**CITY OF TEMPE  
DEVELOPMENT REVIEW COMMISSION**

**Meeting Date: 07/23/2013  
Agenda Item: 6**

**ACTION:** Request for a Planned Area Development Overlay and a Development Plan Review for six (6) new 2-story office development complex consisting of 600,000 sf. of total building area for LIBERTY CENTER AT RIO SALADO, located at 1850 West Rio Salado Parkway. The applicant is RSP Architects.

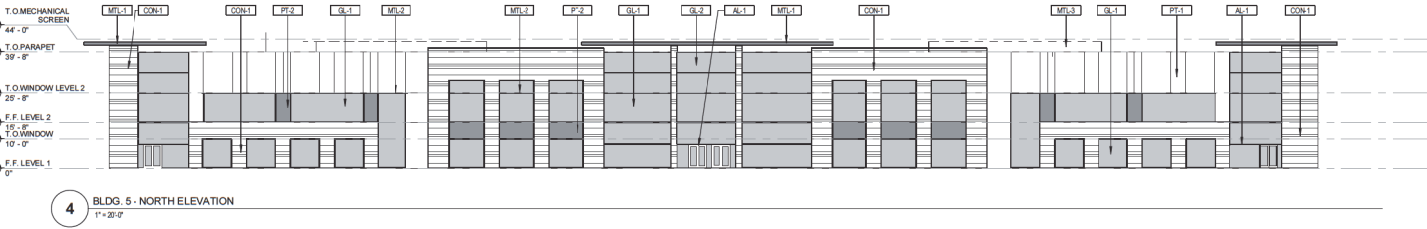
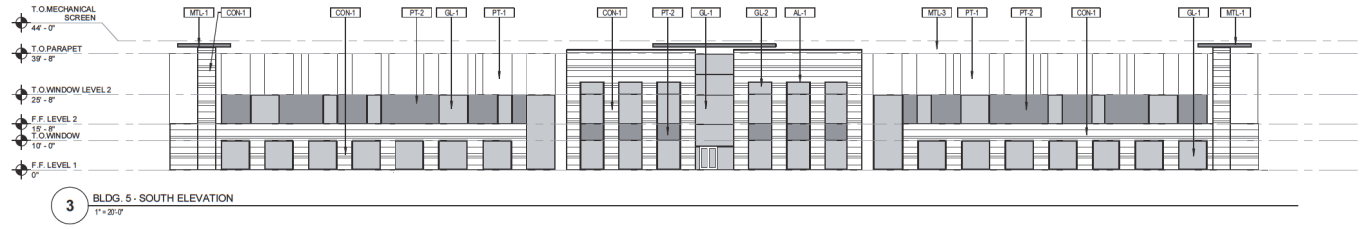
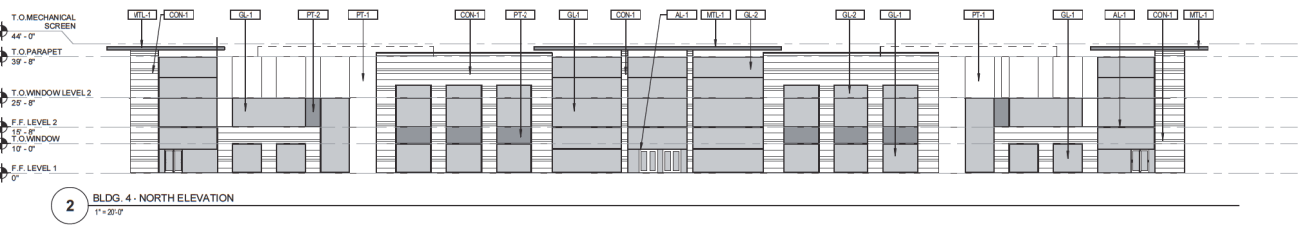
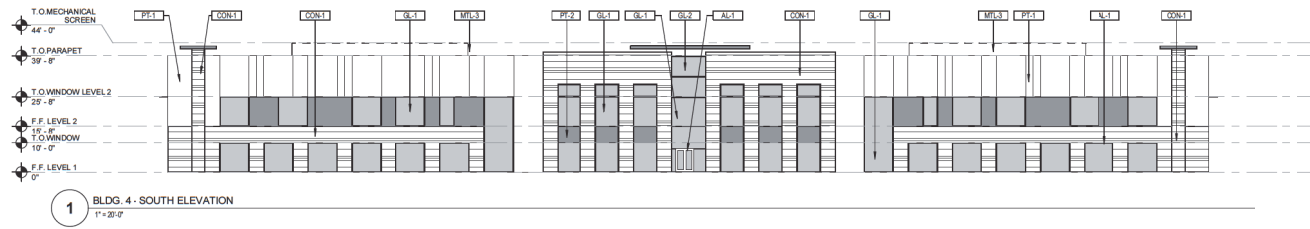
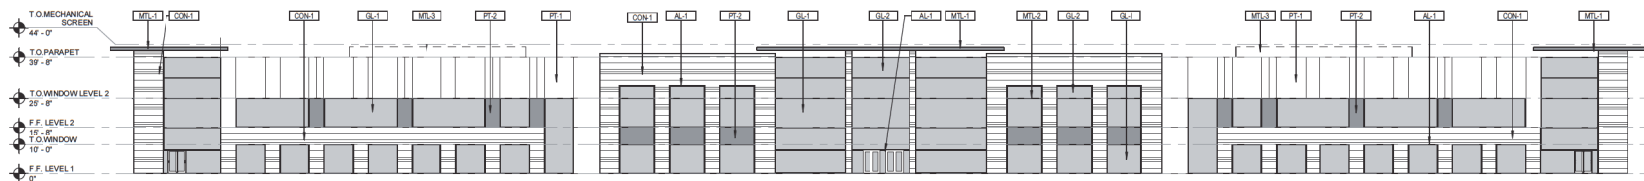
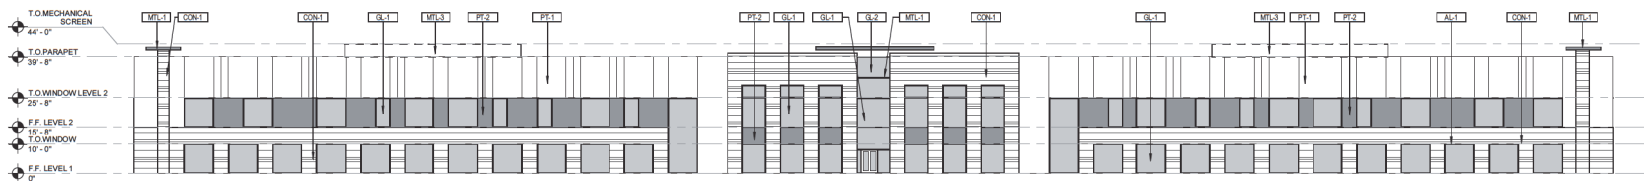
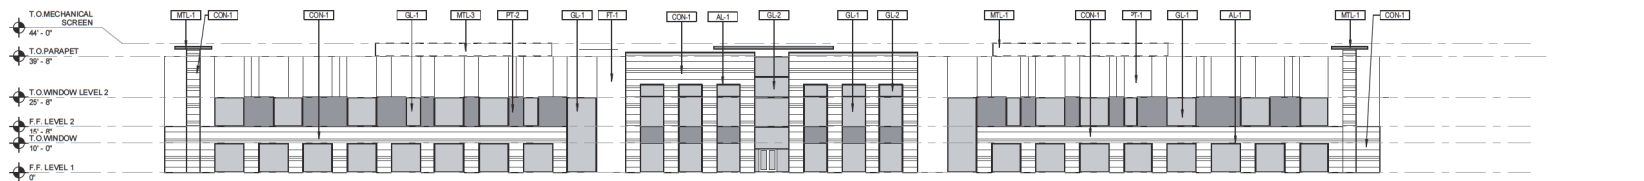
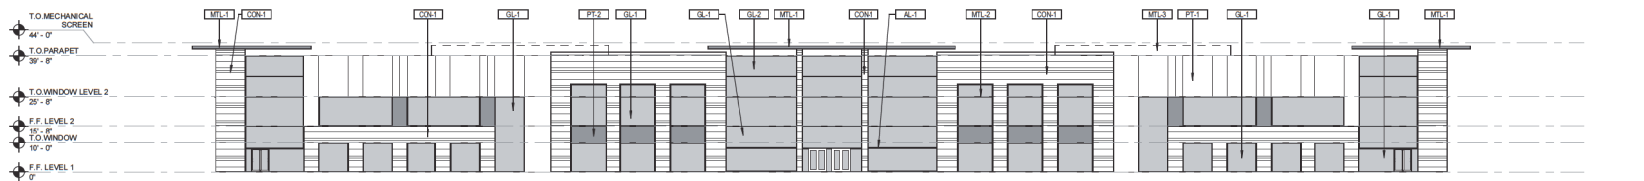
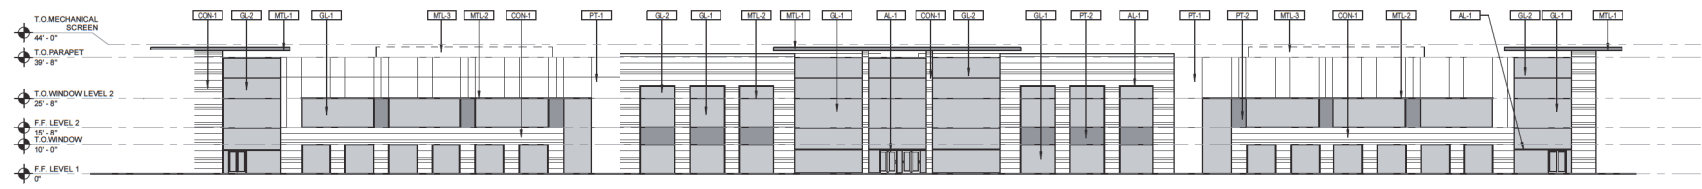
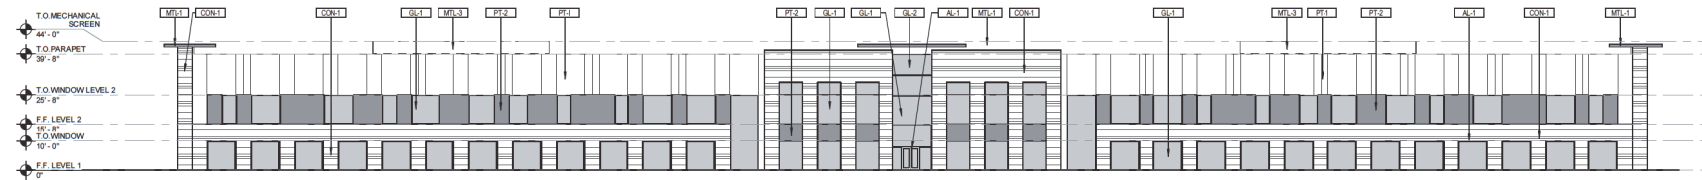
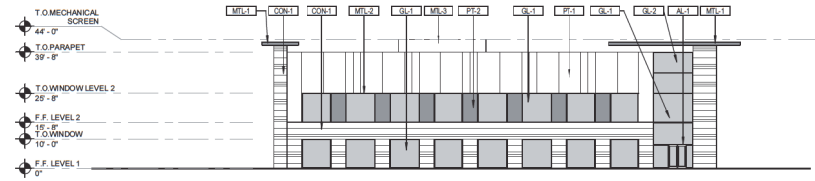
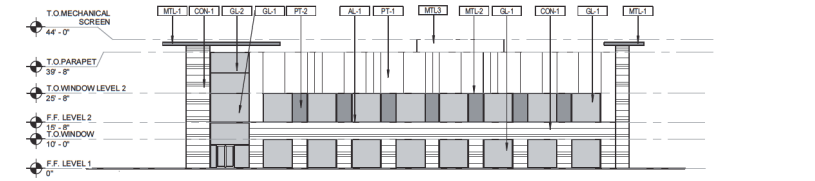
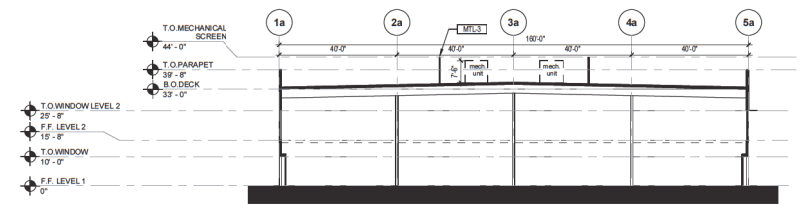
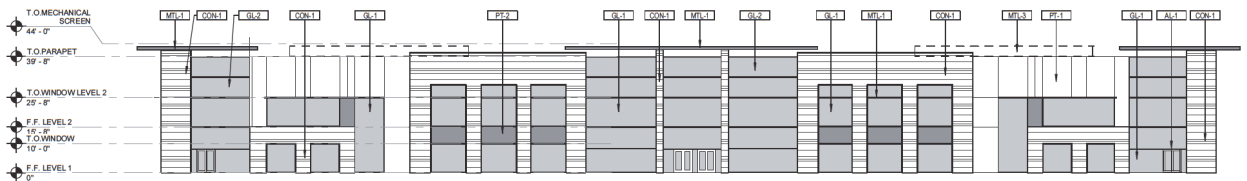
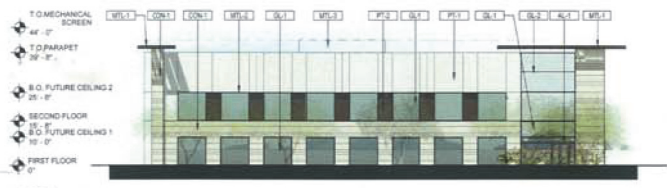
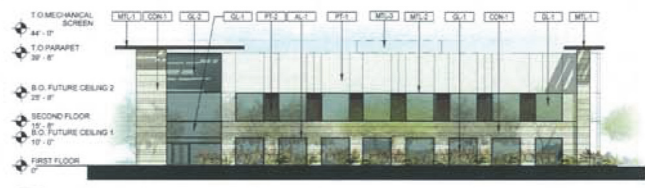
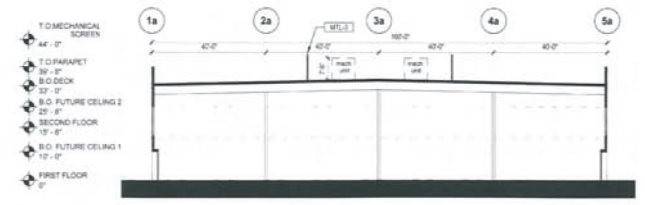
13. The materials and colors are approved as presented:
  - Window Frame – Clear Anodized aluminum fram
  - Concrete – Integral Color Concrete with Formliner – Sandstone 5237

- Spandrel Glass – Opaci Coat 300 "Sunset Green"
  - Metal Trellis – Paint DEA157 "Cellar Door"
  - Metal Shade Fin – Paint DEA157 "Cellar Door"
  - Metal B-Deck Screen – Paint DEC774 "Shady"

- Painted Concrete – DEC774 "Shady"
  - Painted Concrete – DEA157 "Cellar Door"Specific colors and materials exhibited on the materials sample board are approved by planning staff. Additions or modifications may be submitted for review during building plan check process.

14. Provide secure roof access from the interior of the building. Do not expose roof access to public view.
15. Incorporate lighting, address signs, and incidental equipment attachments (alarm klaxons, security cameras, etc.) where exposed into the design of the building elevations. Exposed conduit, piping, or related materials is not permitted.

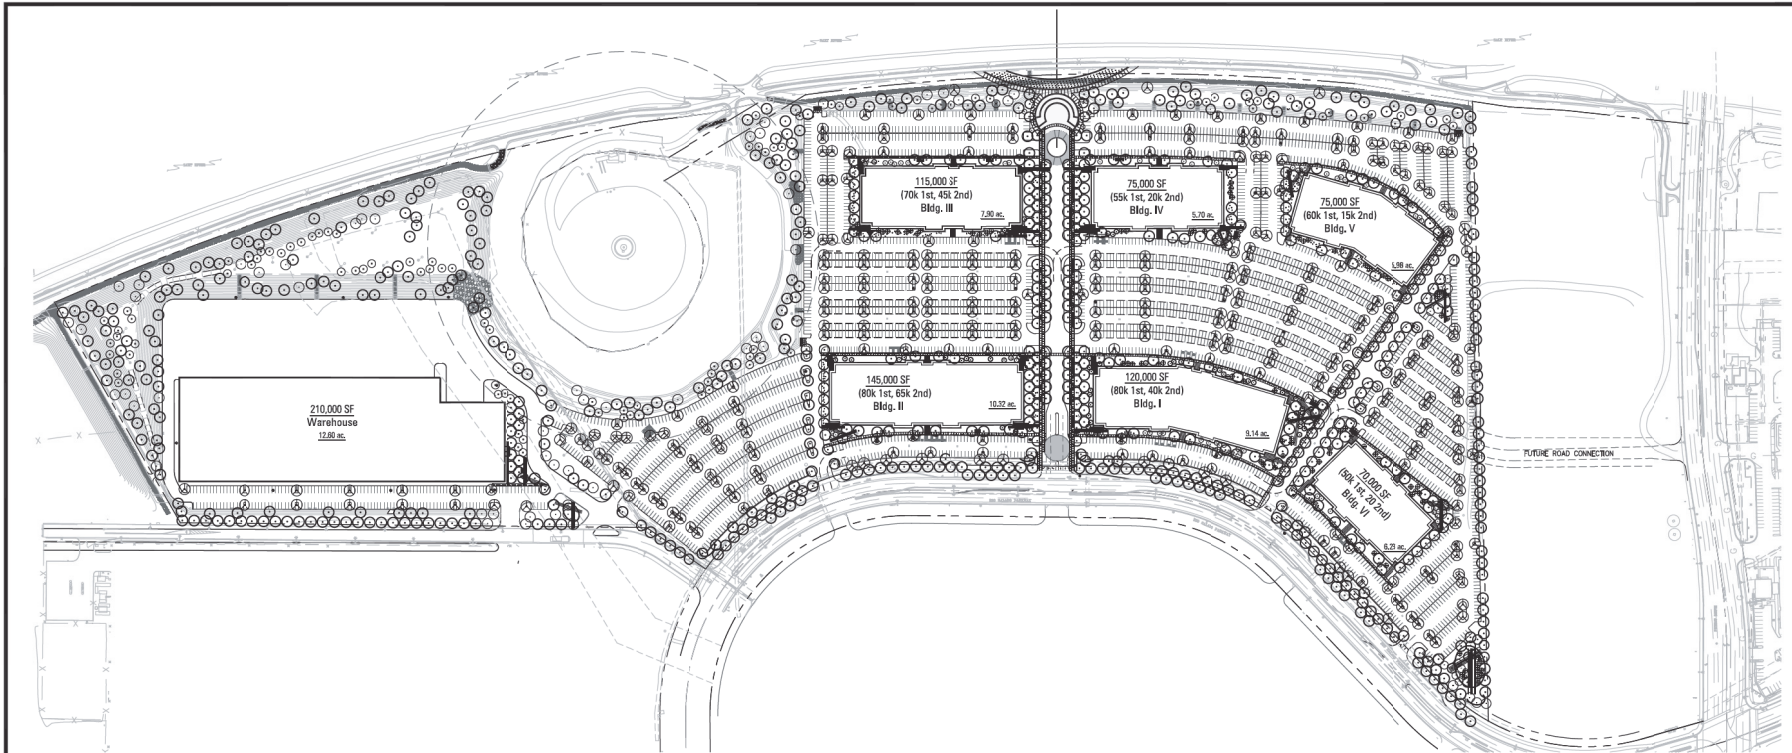
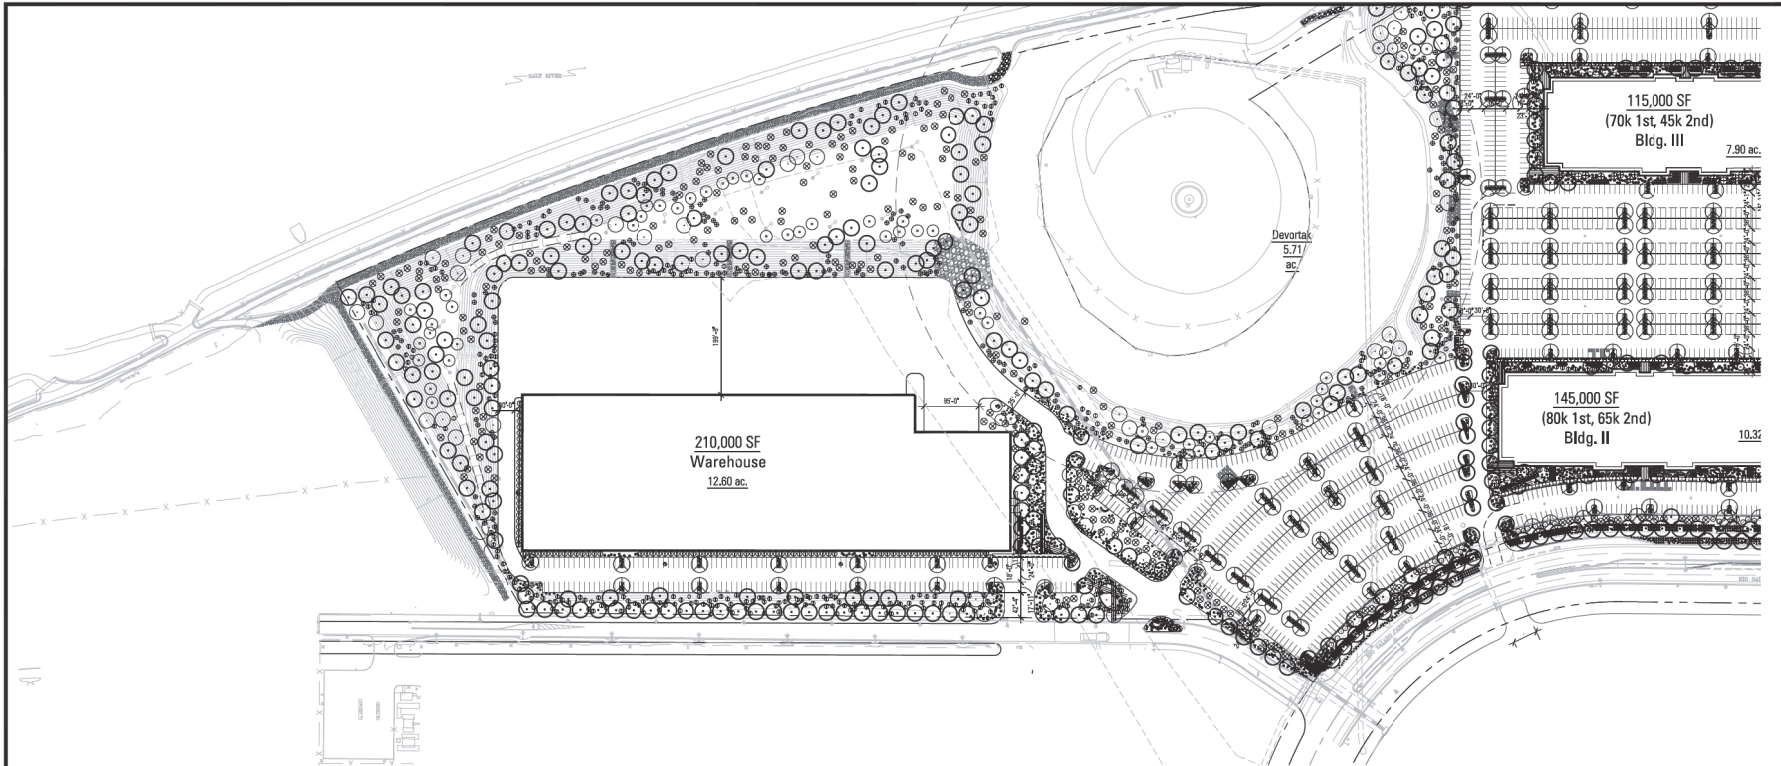
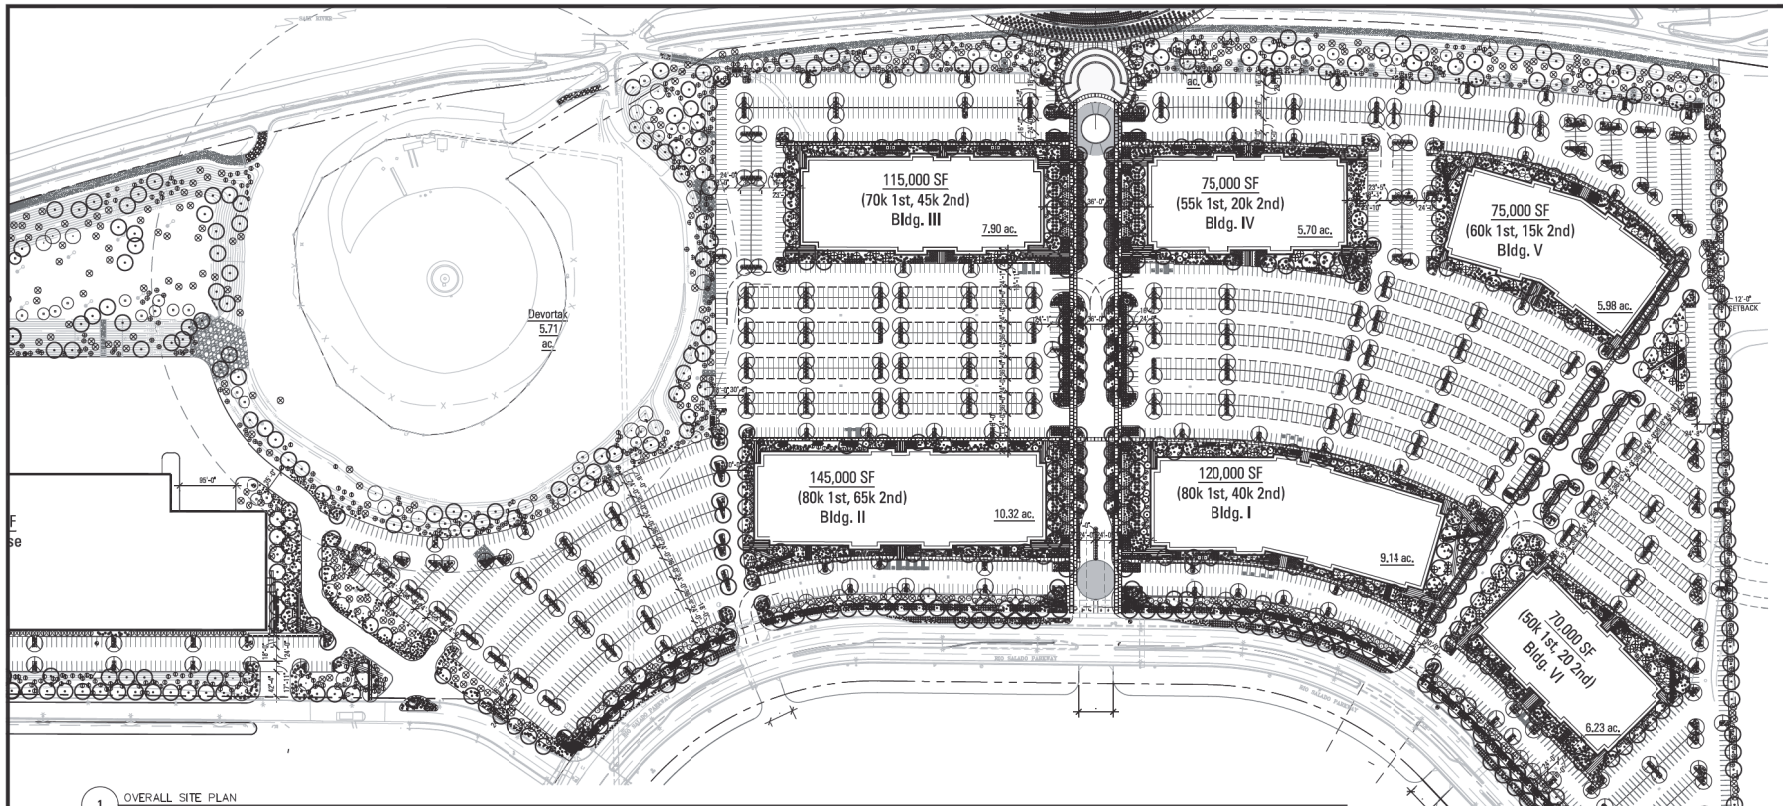
18. The plant palette is approved as proposed and specified on the landscape plan, unless otherwise noted. Any additions or modifications may be submitted for further review during building plan check process.

19. Irrigation notes:
  - a. Provide dedicated landscape water meter.
  - b. Provide pipe distribution system of buried rigid (polyvinylchloride), not flexible (polyethylene). Use of schedule 40 PVC mainline and class 315 PVC 1/2" feeder line is acceptable. Class 200 PVC feeder line may be used for sizes greater than 1/2". Provide details of water distribution system.

20. Include requirement to de-compact soil in planting areas on site and in public right of way and remove construction debris from planting areas prior to landscape installation.

21. Top dress planting areas with a rock or decomposed granite application. Provide rock or decomposed granite of 2" uniform thickness. Provide pre-emergence weed control application and do not underlay rock or decomposed granite application with plastic.

22. Trees shall be planted a minimum of 12'-0" from any existing or proposed public water or sewer lines located on-site. Trees near the main water or sewer lines located within the right of way shall be planted at least 20'-0" away. Final approval subject to determination by the Public Works, Water Utilities Division.
